# Mona Vale Surf Lifesaving Club

S4.55(1A) Modification to Approved Development Consent (DA/2018/1771)

On behalf of  
Northern Beaches Council Property / Building Assets Department.  
November 2019

**Figure 6.** GA Plan – Ground Level (A.DA.10.001)  
Source: Warren and Mahoney

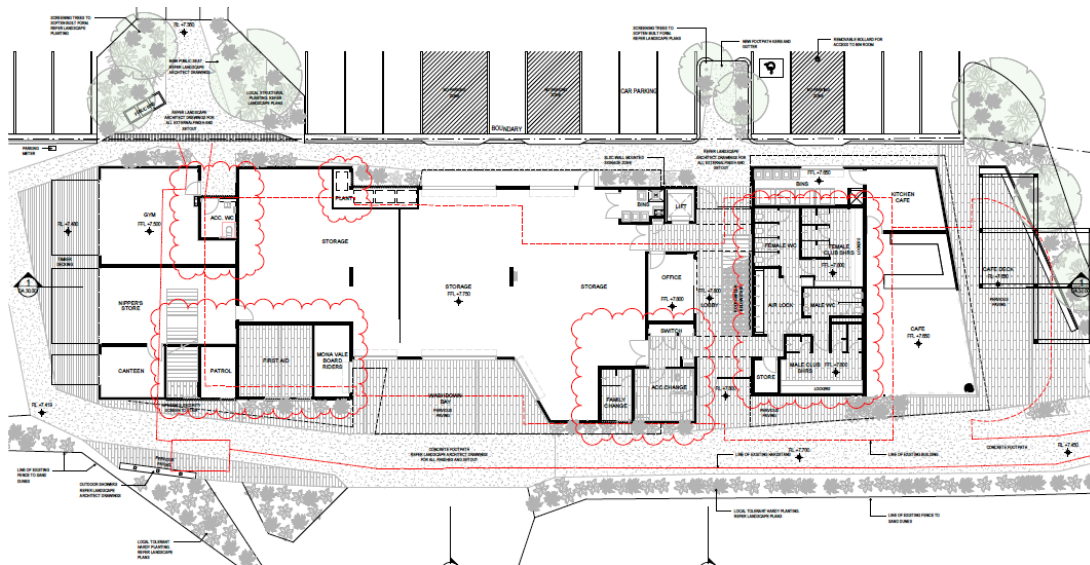
#### Ground Level

- Deletion (and relocation elsewhere) of the public male and female sanitary facilities;
- Addition of public family change facility with entry off eastern elevation;
- Addition of public unisex accessible sanitary facility (with entry off western elevation) adjacent to the gym;
- Infill of smaller through-site link;
- Deletion of lifeguard room;
- Increase area of Nippers storage area;
- Increase area of general club storage area;
- Increase area of first aid room area and relocation (with entry off eastern elevation);
- Relocation of patrol room (with entry off eastern elevation);
- Relocate the club bin store;
- Addition of unisex accessible club change facility (with access off the through-site link);
- Installation of external free-standing shade structure to café deck;
- Increase to gym area with new external entry to gym;
- Ventilated façade to plant area increased on return wall;

- Relocation of Mona Vale Board Riders room with roller door entry on return wall adjacent to beach-side access to general club storage area;
- Removal of roller door and opening on east façade from previous Mona Vale Board Riders location;
- External staircase shifted to allow room for ground floor landing behind operable security screen; and
- Amendments to club change room layout.

**Figure 7.** GA Plan – Level 1 (A.DA.10.002)  
Source: Warren and Mahoney

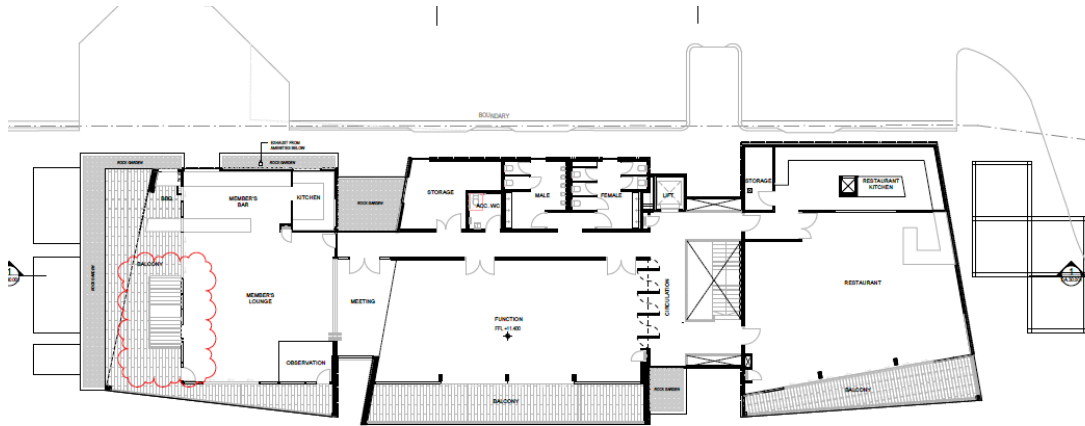
#### Level 1

- Deletion of meeting room adjacent members' bar / kitchen;
- Relocation of members' kitchen, adjacent bar;
- Addition of access via sliding door between members' bar and external BBQ area;
- Addition of bench in external BBQ area;
- Increase glazed balustrade height to 1800mm on south and east elevations of southern balcony;
- Relocation of observation room;
- Addition of increased internal flexibility of function space to enable sub-division into meeting room space;
- Deletion of meeting room off central corridor;
- Increase storage room area, adjacent sanitary facilities;
- Relocation of unisex accessible sanitary facility, from restaurant to serve entire surf lifesaving club; and
- External staircase shifted to allow room for ground floor landing behind operable security screen.

**Figure 11.** Western Elevation – (A.DA.20.002)  
Source: Warren and Mahoney

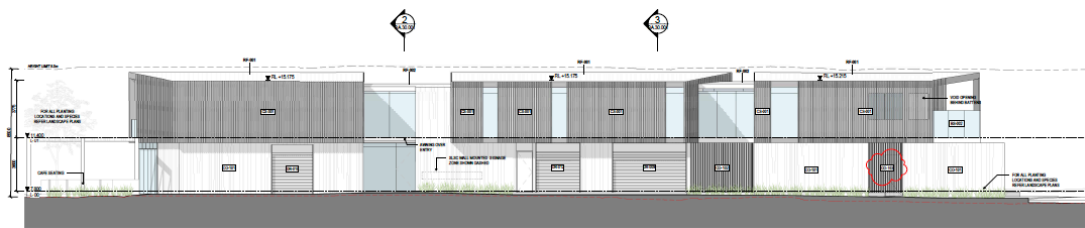
- Deletion of ground floor public female and male sanitary facilities (on the basis that Council is concurrently proposing to improve and increase the existing sanitary facilities at Mona Vale Beach, within 150metres of the club as well as providing new toilet facilities in Apex Park, within 50metres);
- Minor modifications to the internal configuration as detailed below in **Section 3.1** with subsequent infill of through site link; and
- Installation of an external free-standing shade structure added to café deck.

**Figure 14.** Ground Level Plan (A.DA.10.001)- Modification as Proposed.

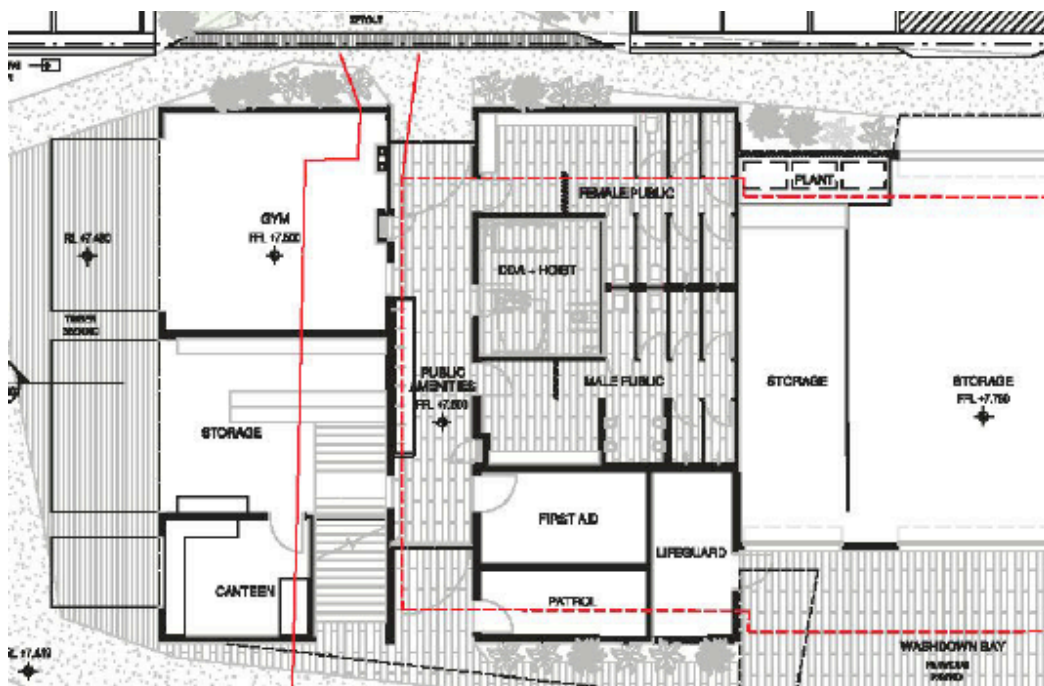
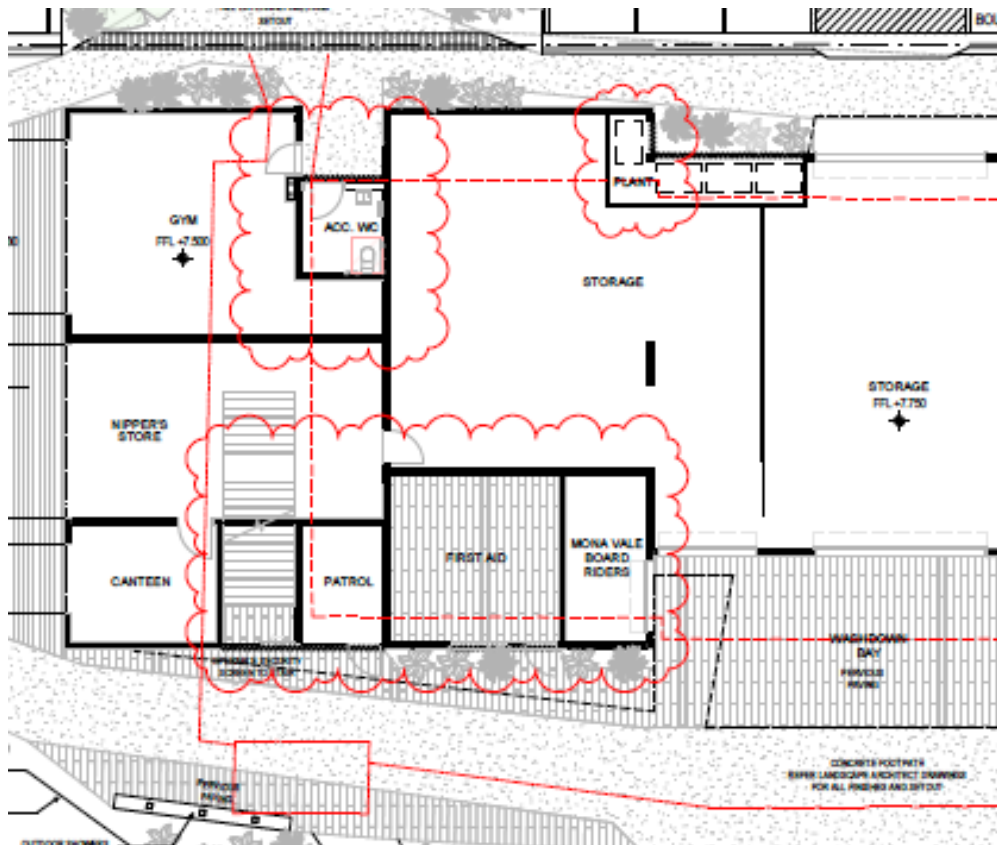
The original DA provided two (2) on site through links, which were deemed to improve the existing views from Apex Park to the Beach. This proposal includes the removal of smaller of the two through-links which will permit additional space needed for the operation of the Mona Vale SLSC. It is considered that the smaller through site link contributed little in terms of amenity and additional viewscape from Apex Park to the beach or views from the building to the beach. (Refer to **Figure 13** and **Figure 14** to for details on approved (DA2018/1771) vs proposed). This modification will not cause any additional view impacts to or from surrounding properties. The proposed modification and provision of additional storage and operational areas including a larger First Aid room is deemed to provide a greater benefit to the community when compared to the limited benefit provided by maintaining the through site link.

The removal of the smaller of the two internal through-site links will allow the internal reconfiguration of the space which in turn will create additional storage, and operational areas, which is considered to provide a greater benefit to the community when compared to the benefit of maintaining the through-link. The proposed works will not alter the approved building envelope. Overall the built form, as viewed from the public domain, will remain unchanged.
